## 5.4 Components and Subsystem Design

The information in this section of the reference ABWR DCD, including all subsections, tables and figures, is incorporated by reference with the following departures and supplements.

**Figure 5.4-1 Reactor Internal Pump Cross Section**

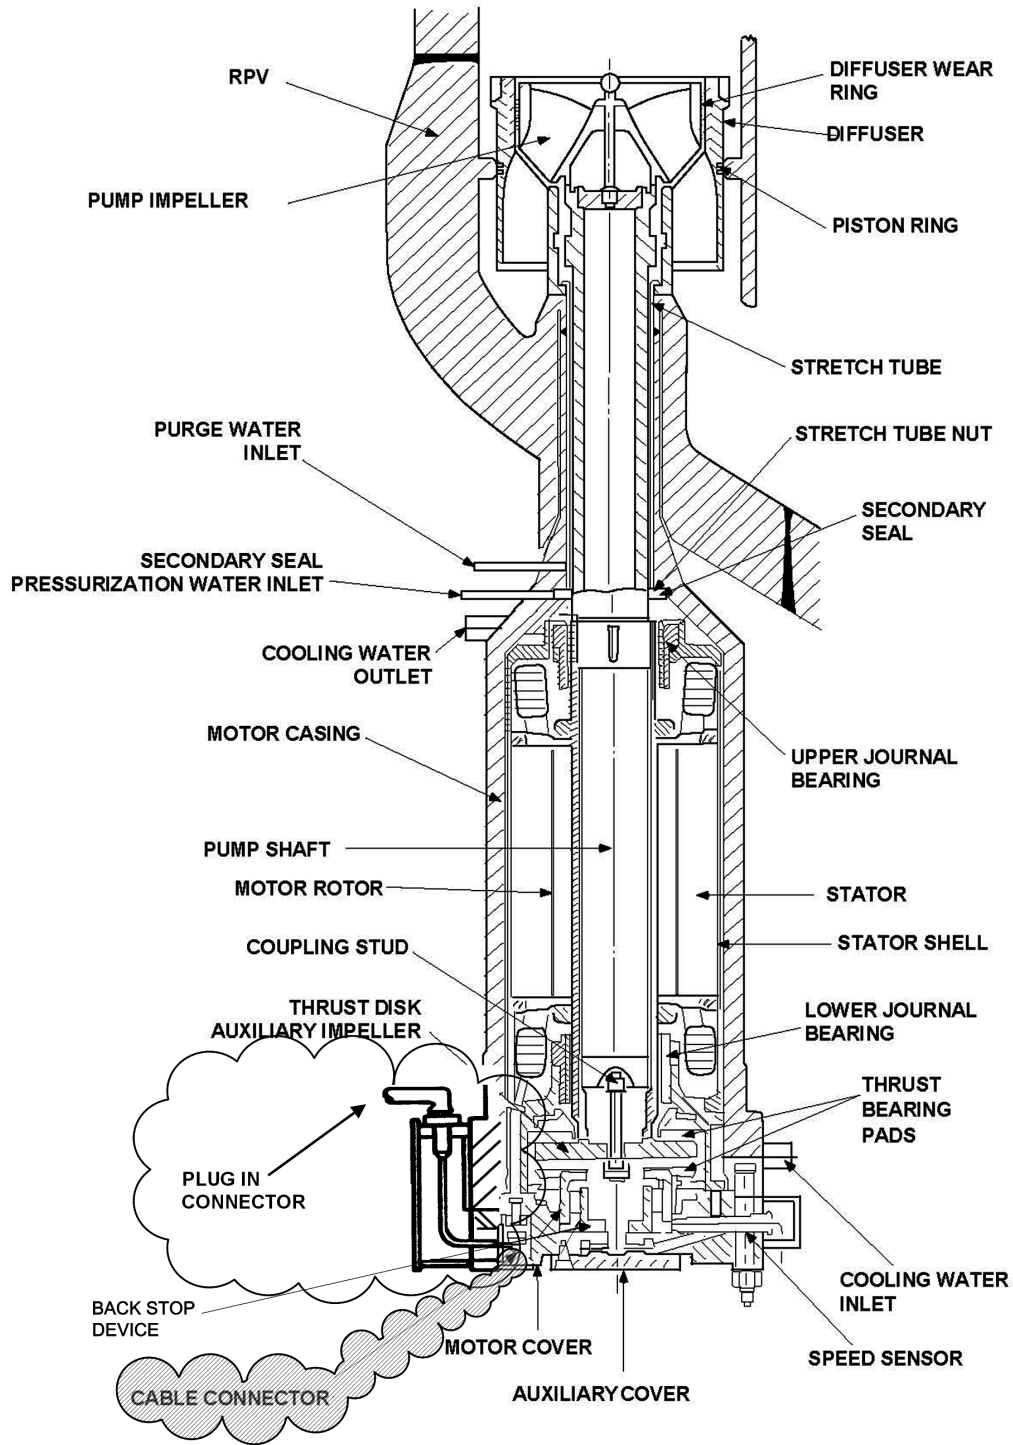
[STD DEP 5.4-2 \(Figure 5.4-1\)](#)
